## LMI CRP Discussion

*July 22, 2021  
10:00 AM – 12:15 PM PST  
Teams call  
# 20446521-006-MM-Rev0-1000*

PROJECT  
LANDFILL EXPANSION DETAILED DESIGN  
LUPIN MINE CLOSURE  
NUNAVUT, CANADA

### SUPPLEMENTAL INFORMATION ON THE DESIGN OF THE DOME AND THE LANDFILL

TYPICAL DETAIL OF PERIMETER BERM  
N.T.S.

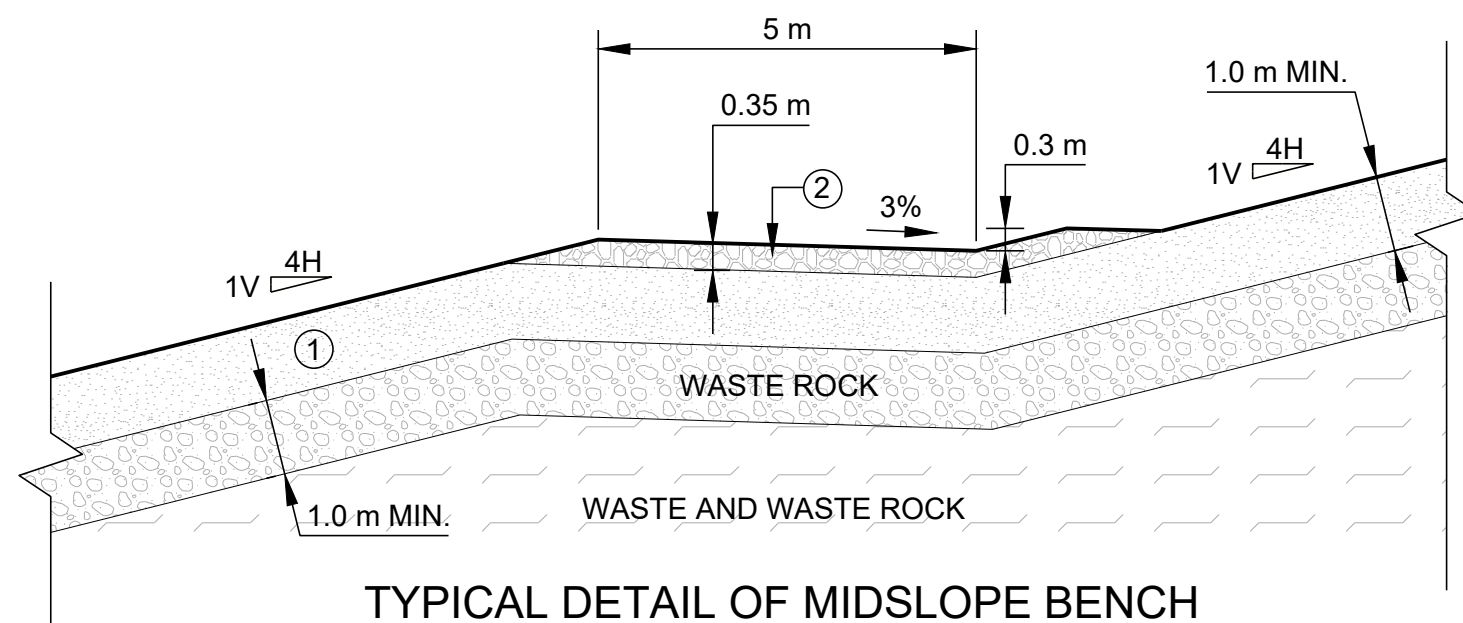
Discussion Items	Item Owner
<p>4. Dome design Package (Part G WL), Section 2 Item c): Slope Erosion - Potential for rilling of longer slopes – outstanding, looking for context/design basis/analogue for self-armouring; and how robust is berm design (esker material)?</p> <ul style="list-style-type: none"> <li>KB – analogue is experience, based on dam designed previously elsewhere with a downstream slope of 2:1 of exposed esker gravel – has performed well based on &gt; 15 years of annual inspections; therefore, the expectation is that a 10:1 slope will perform well providing we prevent external runoff from the top surface of the dome from going over the slope.</li> <li><b>GW – please put above into response</b></li> <li>GW - Perimeter berm is 0.5m high with 2:1 slopes on either side– should have downslope armour in case of long-term erosion/icing events?</li> <li>KB – perimeter berms are just esker, (see detail in Rev. 1 dwg.) KB is comfortable with that as the longitudinal slope is very low (&lt;1%); TCA esker cover (with a slope of about 1%) has performed quite well over the years with respect to sheet flow from runoff.</li> <li><b>GW – please put logic above into response</b></li> <li>AT –at freshet, the esker cover is frozen and not very susceptible to erosion.</li> <li><b>KB – will provide additional information re: basis of design and comfort</b> Dome design Package (Part G WL), Section 2 Item d) and e)</li> <li>GW - Toe erosion from discharge chute runoff; didn't provide technical basis on design of stilling basin and exit velocities; dwg note to confirm positive drainage away from the toe</li> <li>CG – did KB intend for chute to settle in a pond?</li> <li>KB - 10% slope is supercritical flow, so we included stilling basins at the bottom of each chute to dissipate energy. The stilling basins are imbedded into original ground to force the hydraulic jump. Flow exiting the stilling basins will be low velocity subcritical flow. We will field fit the proper drainage to ensure there will be positive drainage away from the toe. Golder will have an earthworks inspector on site in the fall to view the field fits.</li> <li><b>KB – will document/respond above</b></li> </ul>

No erosion protection is planned to be placed on the inside of the esker berm around the perimeter of the top surface of the dome. The slope along the inside of the berms towards the inlet of the chutes is very gentle, so the flow velocities will be slow. It is noted that the esker cover on the Tailings Containment Area (TCA) has not eroded even though it typically slopes at roughly 1%.

DRAINAGE CHUTE TYPICAL CROSS-SECTION  
N.T.S.

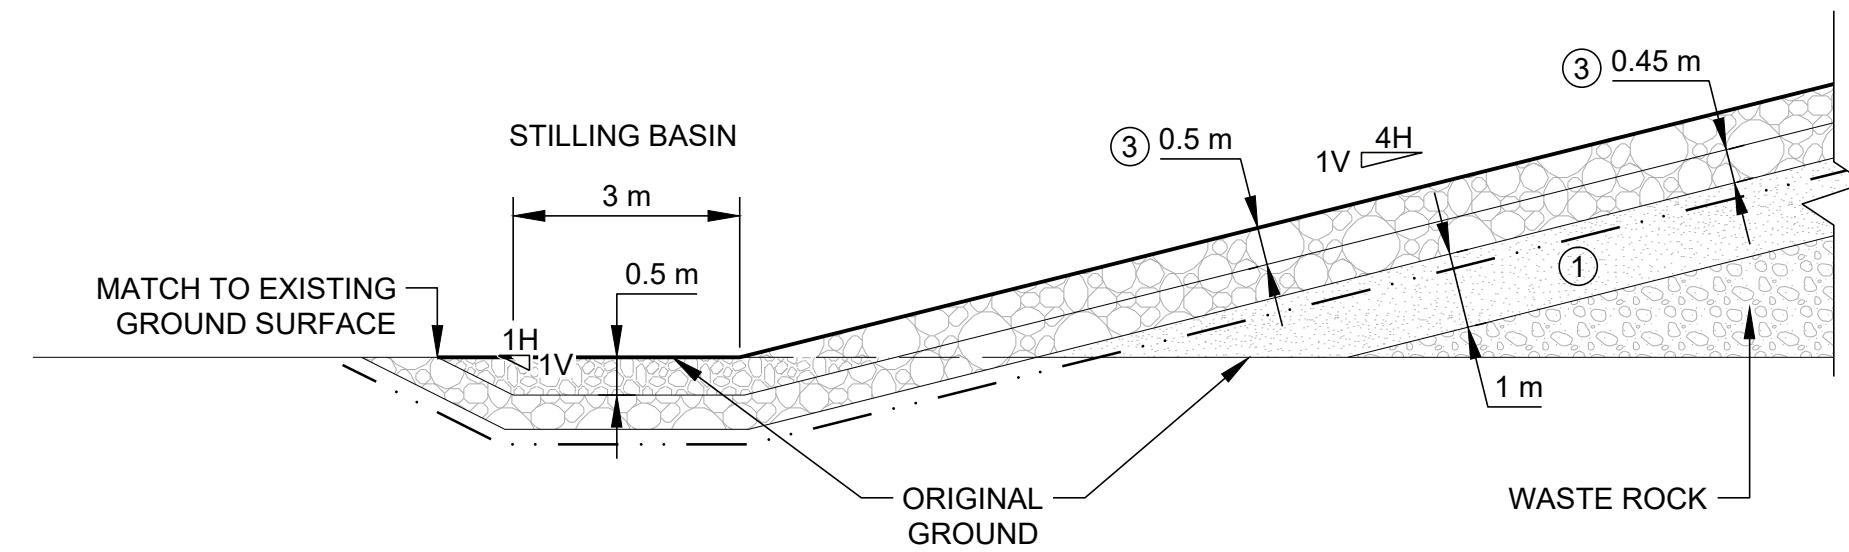
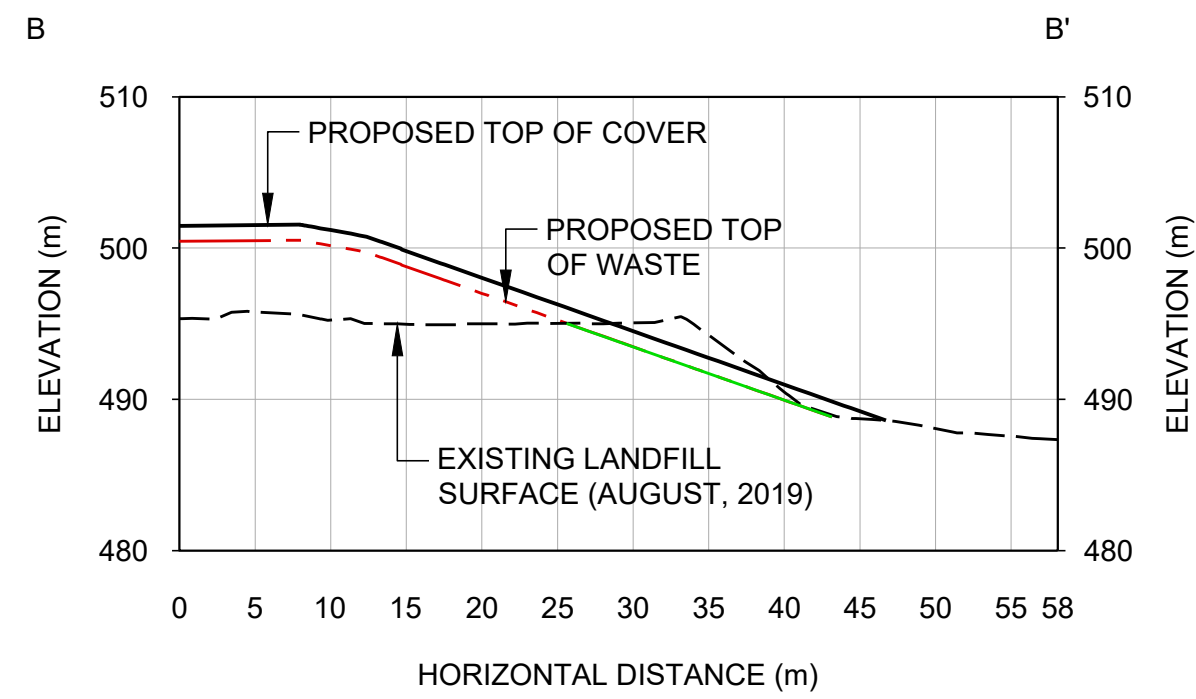
2.	Dome Design Package (Part G WL), Section 2 Item a) : GW - Lack of detail grading info on dome – addressed	
3.	<p>Dome design Package (Part G WL), Section 2 Item b)</p> <p>GW - Lack of design information on storm/freshet flows – outstanding / partial response</p> <ul style="list-style-type: none"> <li>GW – noted Golder had provided design capacity of each chute, but not the design flows expected for each chute?</li> <li>KB – 1m<sup>3</sup>/sec, not tied to particular design storm, each chute has 2 hectares or less reporting to them</li> <li><b>GW – suggests KB provide information on predicted runoff from design storms and freshet to allow for comparison to chute design capacity</b></li> </ul>

The dome incorporates 6 chutes to carry runoff from the top surface down to the toe of the dome. For the design of the chute capacity and erosion protection sizing, a presumptive high flow of 1.0 m<sup>3</sup>/sec. was used. CIRNAC requested that this flow be related to a design storm or freshet flow.

The top surface of the dome has an area of approximately 8 hectares. On average, the contributory area for each chute is about 1.33 hectares. The nearest meteorological station for which intensity - duration-frequency (IDF) curves are available is Fort Reliance, Northwest Territories. The IDF curves are attached for information. For the minimum collection time of 5 minutes, the intensity that corresponds to a 100 year return rainstorm is 105 mm/hr. or 0.029 mm/sec. For the 1.33 hectare contributory area, the expected flow down each chute would be about 0.39 m<sup>3</sup>/sec. In other words, the return period for a storm that would generate a flow of 1 m<sup>3</sup>/sec. considerably exceeds 100 years. A freshet from spring melting is not expected to generate such intense flows.

A stilling basin has been incorporated at the base of each of the chutes. The 10% slope on the chutes will result in supercritical (i.e., high velocity, shallow depth) flow conditions. The chute erosion protection has been sized for the high velocities. The stilling basins are designed to force a hydraulic jump which will result in subcritical (low velocity) flow exiting the stilling basins and flowing over original ground. The stilling basins are designed to be imbedded 0.5 m into original ground to contain the hydraulic jumps.
